Appendix H

Traffic assessment issues analysis and response

To: Thomas Frankham
From: Ody Murlianto
Subject: **Hunter Valley Operations Continuation Project EIS Review**
Our ref: PS204979-SYD-PAM-MEM-002
Date: **13 October 2023**

Figure 2.1 Warrants for turn treatments on major roads at unsignalised intersections

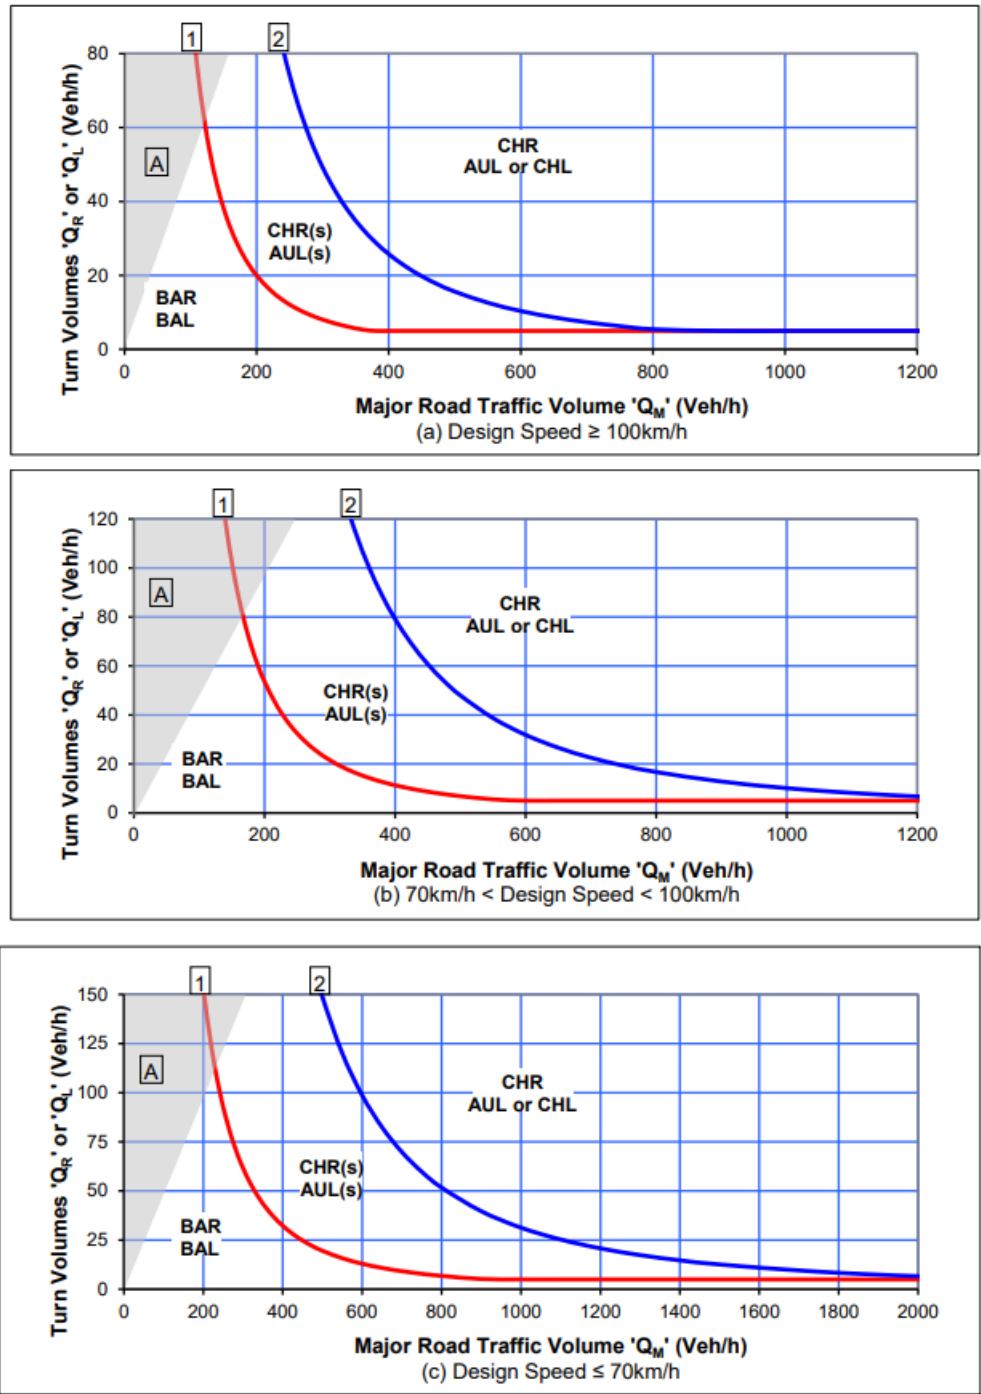
In Section 5.2.1 of the submitted TIA, an upgrade of the intersection of the Golden Highway / Comleroi Road to include an CHR and AUL is identified. Further discussion on how these upgrades have been calculated is sought in accordance with Figure 3.25 from Austroads Guide to Traffic Management Part 6: Intersections, Interchanges and Crossing Management.

Upgrades to the intersection were determined via a warrant assessment for a Type BA, AU and CH turn treatment. This was done by analysing the traffic volume demands on the minor and major roads at the intersection and assessing these values against the graphs shown in Figure 3.25 from *Austroads Guide to Traffic Management Part 6: Intersections, Interchanges and Crossing Management* (see Figure 2.1 below).

Curves 1 and 2 shown in the diagram are applicable for two-lane two-way roads to depict the boundary between the different treatments (basic and short/regular auxiliary or channelised lanes). For roads with four or more lanes, curve 1 becomes the boundary between a basic and regular auxiliary or channelised lane. Its evaluation mainly focuses on safety performance outcomes, rather than operational. This methodology assesses the need for priority-controlled intersections to provide basic (BA), auxiliary (AU) lane or channelised (CH) lane treatments.

Table 2.2 Comleroi Road–Golden Highway intersection warrant assessment with Lemington Road realignment and HVO private driveway closure

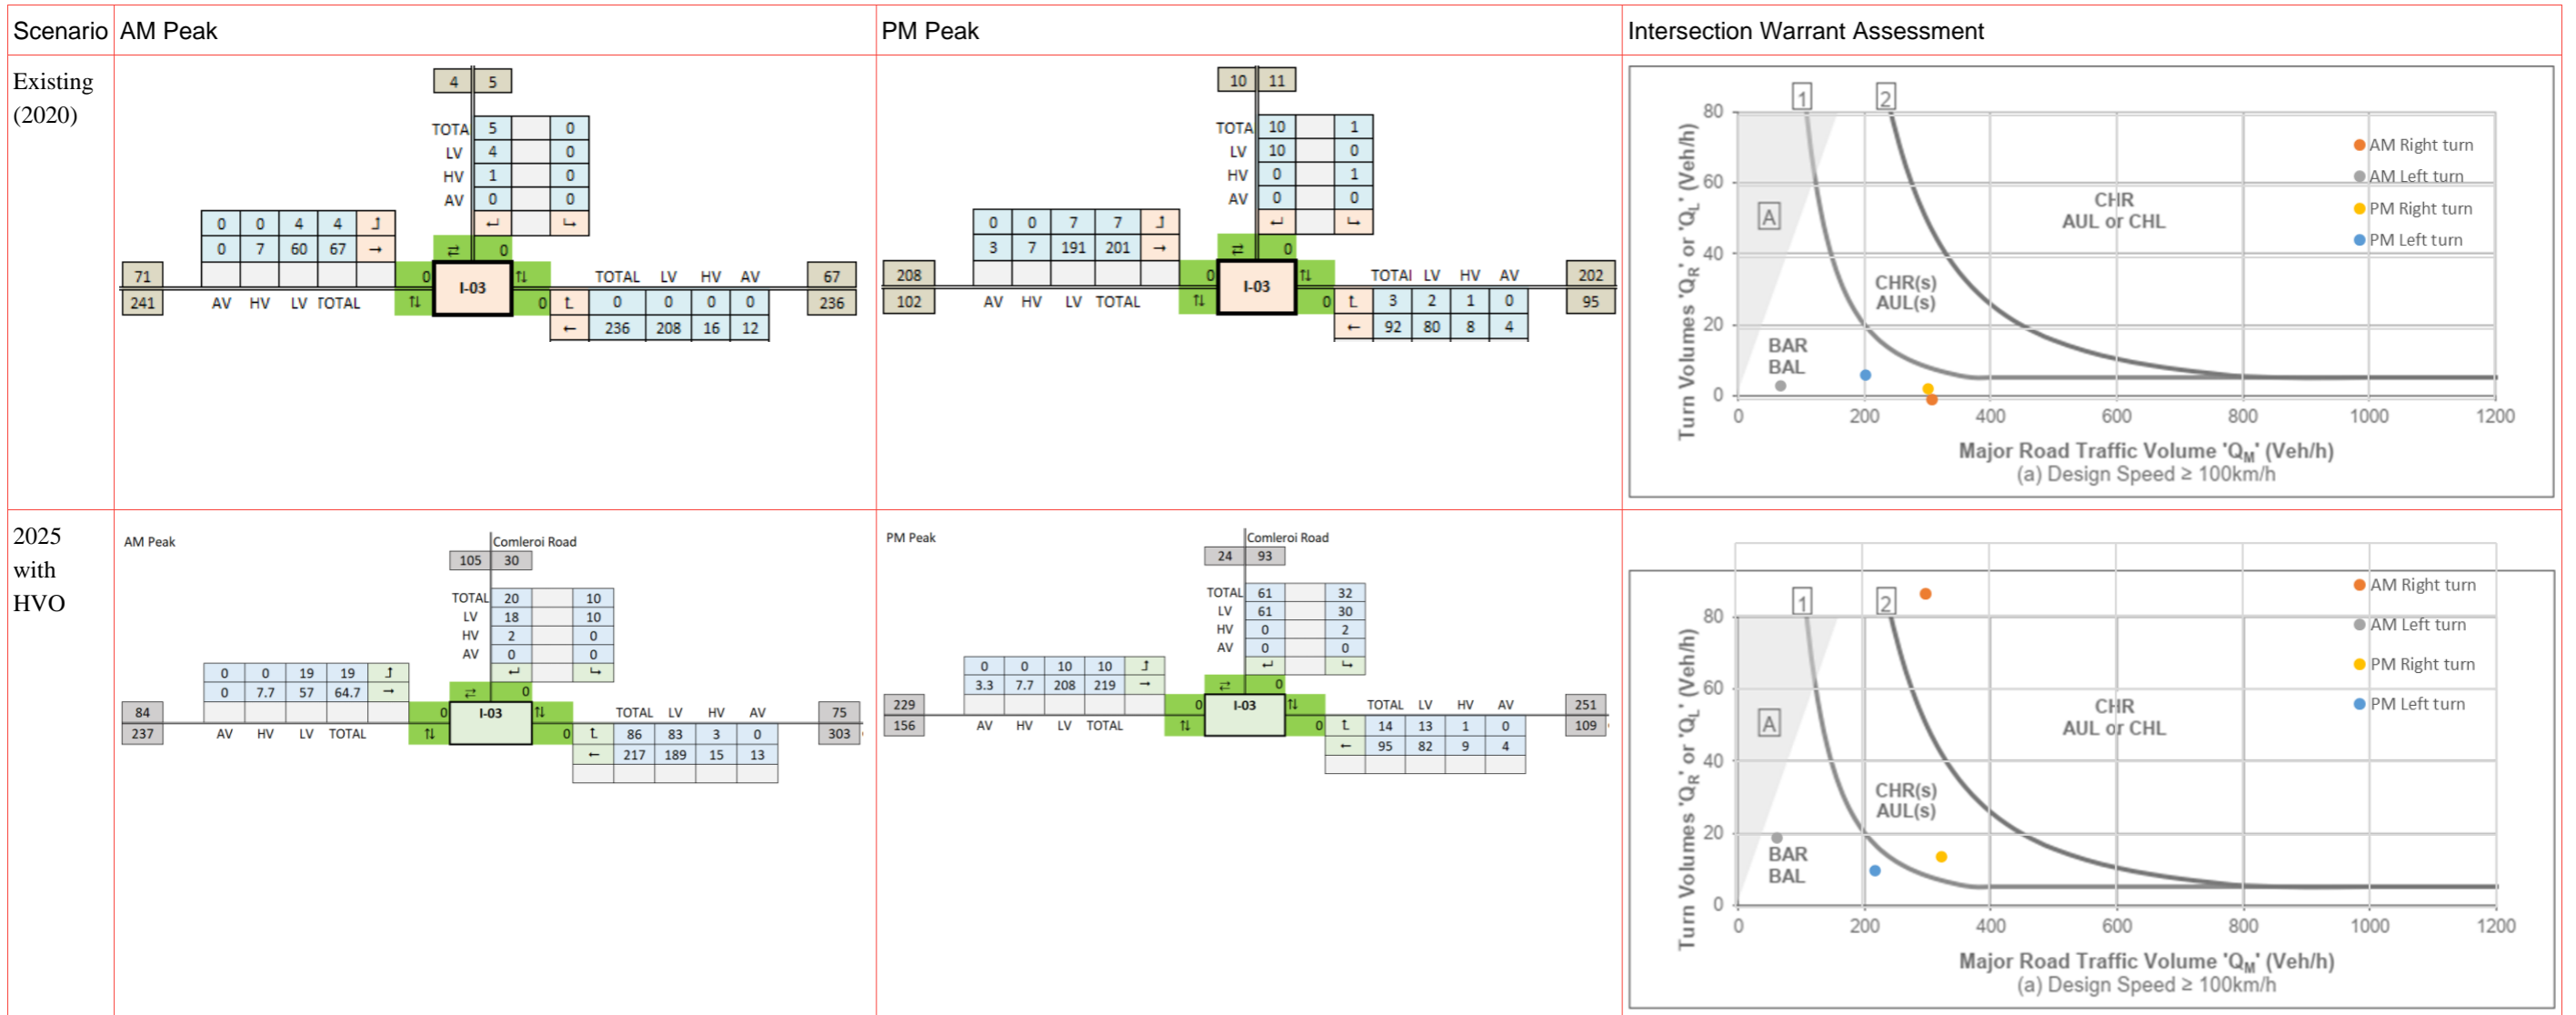
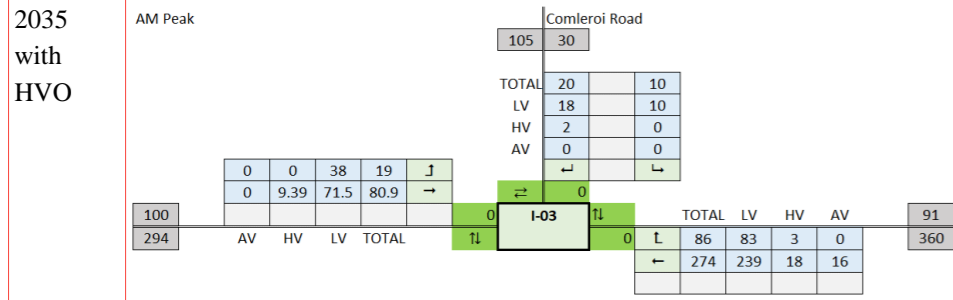
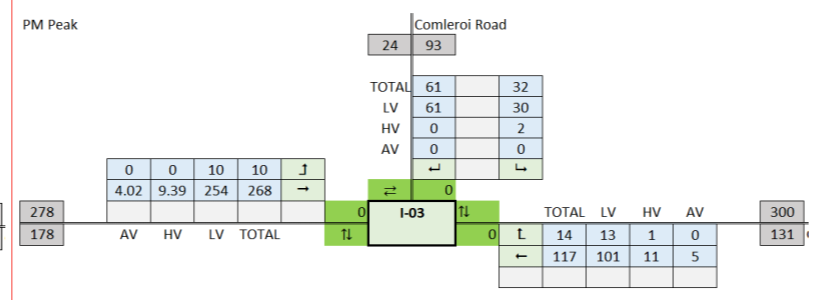
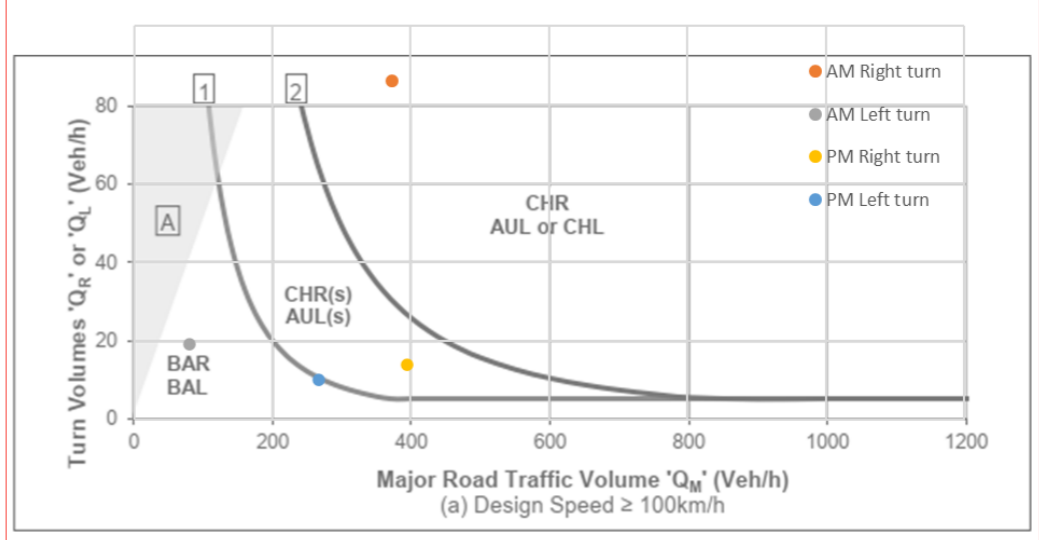
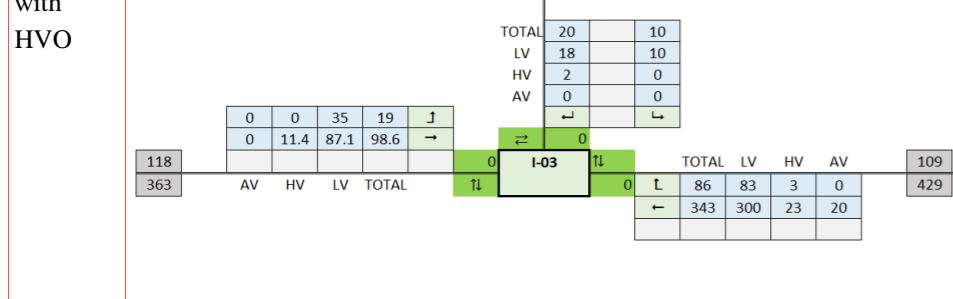
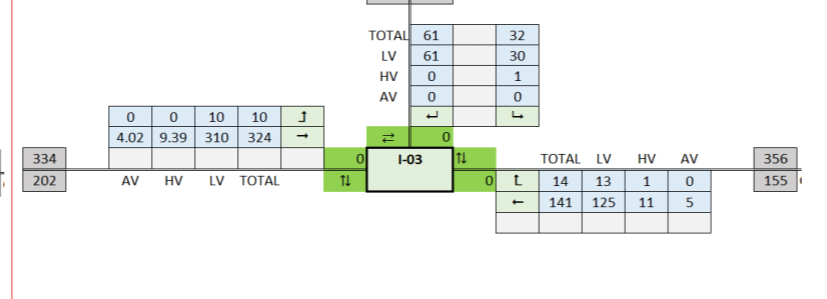
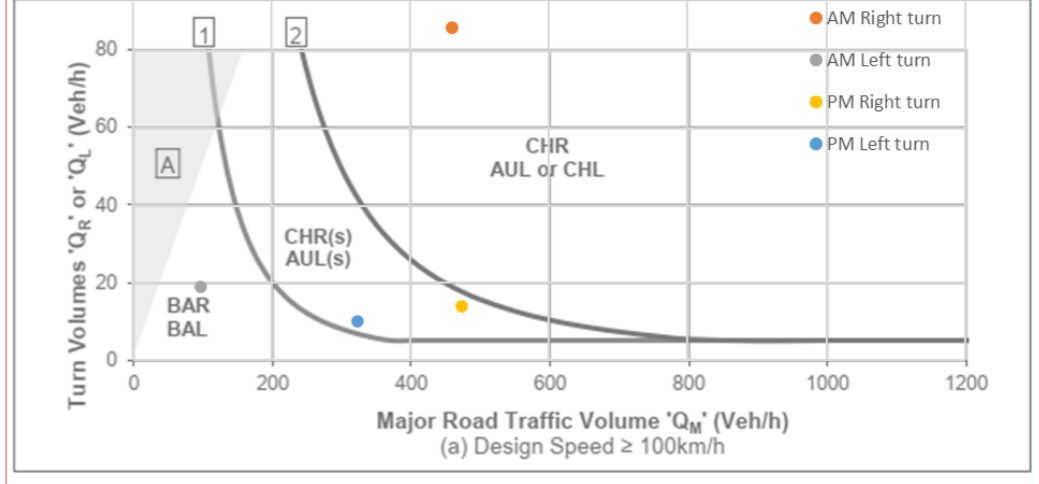
Additionally, consider the impact of the proposed closure of HVO private access driveway between Comleroi Road and the Golden Highway in the turn treatment warrant assessment.
3. Assess the suitability of the current HVGC access driveway layout with their current operation (vehicle size, ingress/egress movements and sight distance to the road network) and the proposed impact due to the realignment of Lemington Road.
4. Consider potential traffic and transport impact of the proposed Lemington Road revised alignment in the northern section of the project area to avoid Warkworth Sands Woodlands Ecosystem.

All traffic that would utilise this private driveway to access Golden Highway (and the reverse) would now use the Comleroi Road-Golden Highway intersection. The amount of daily traffic that utilises this driveway is 610 vehicles per day which equates to approximately 60 vehicles in a peak hour. Table 2.2 illustrates the impact of this change to the warrant assessment.

Overall, this change would result in the CHR requirement on Golden Highway, initially triggered in 2035 with HVO, to be needed earlier in 2025 with HVO. The AULs (as a minimum) is required earlier in 2035 instead of 2045.

The proposed AUL and CHR treatments would still satisfy the warrant requirement at the intersection, with the closure of the private driveway.

Figure 2.3 New England Highway (ID 6153) traffic volume pattern (vehicles per day)

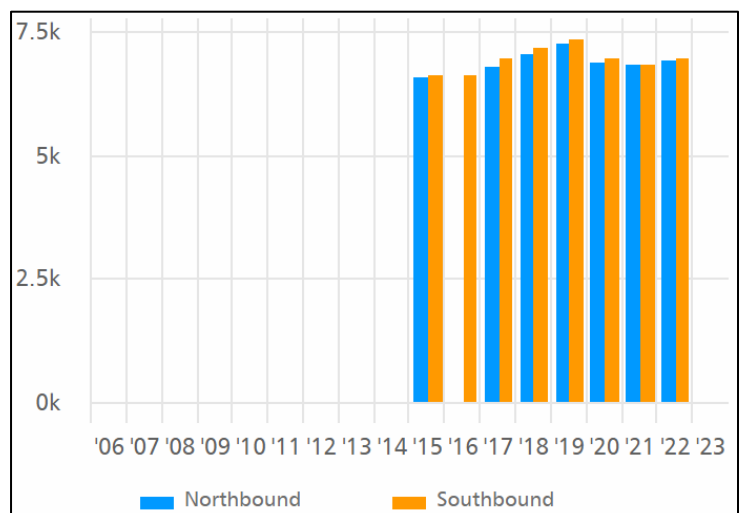
In Section 2.2.1 of the submitted TIA, a discussion is present upon the data collected during the COVID-19 lockdown. It is recommended that an analysis be given with any recent available traffic volumes to determine appropriate baseline data.

TfNSW's Traffic Volume Viewer ID 6153 collected data on the New England Highway up until March 2022. The AADT in 2022, up until it stops operating, was **13,915** vehicles per day, which is lower than those surveyed in September 2020.

As shown in Figure 2.3, the traffic demand on the New England Highway has not grown since 2020. The traffic growth observed in the years prior to COVID-19 pandemic has not been observed in recent years.

As such, the traffic data collected in September 2020, as reported in the TTIA, is considered appropriate to be used as baseline assessment.

Figure 3.4 Golden Highway east of Lemington Road – heavy vehicle volumes (total)

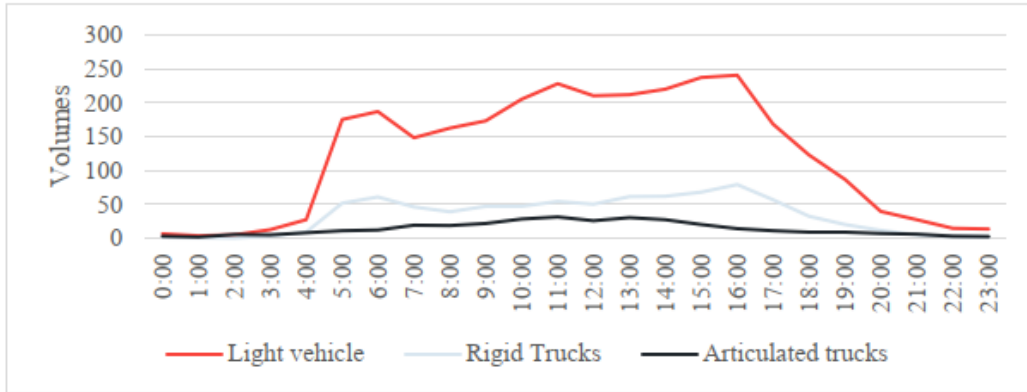
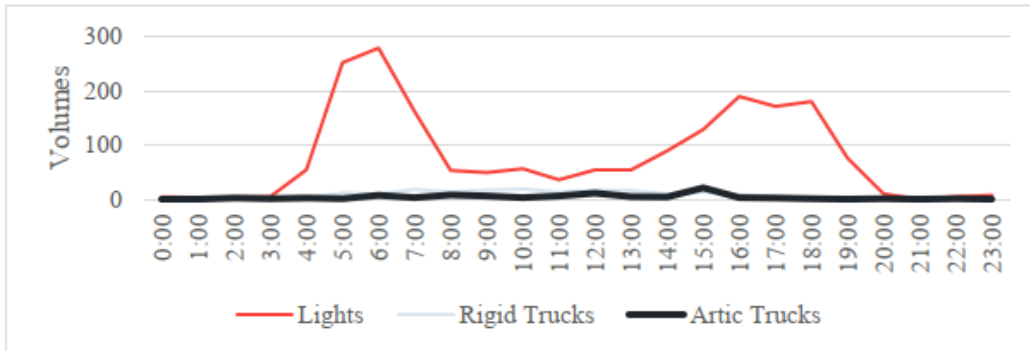
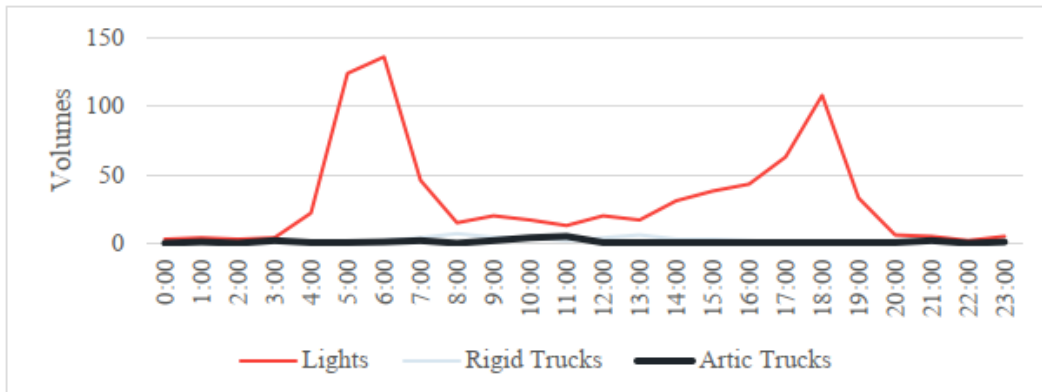
Additional commentary is sought as to why the 6-7am peak was used noting that slightly higher traffic volumes were identified between 5-6am. Is this the time that the employee shifts start and finish?

The 6am-7am peak period was used for the assessment as this was found to be the peak traffic activity for HVO and on the Golden Highway. See images below.

A 5am-6am peak was found on the New England Highway only. Additionally, the intersection surveys across the study area covered periods from 6am onwards, which was decided given the information available at the time. As a result, the peak periods were also validated from these surveys, indicating a peak period between 6am and 7am.
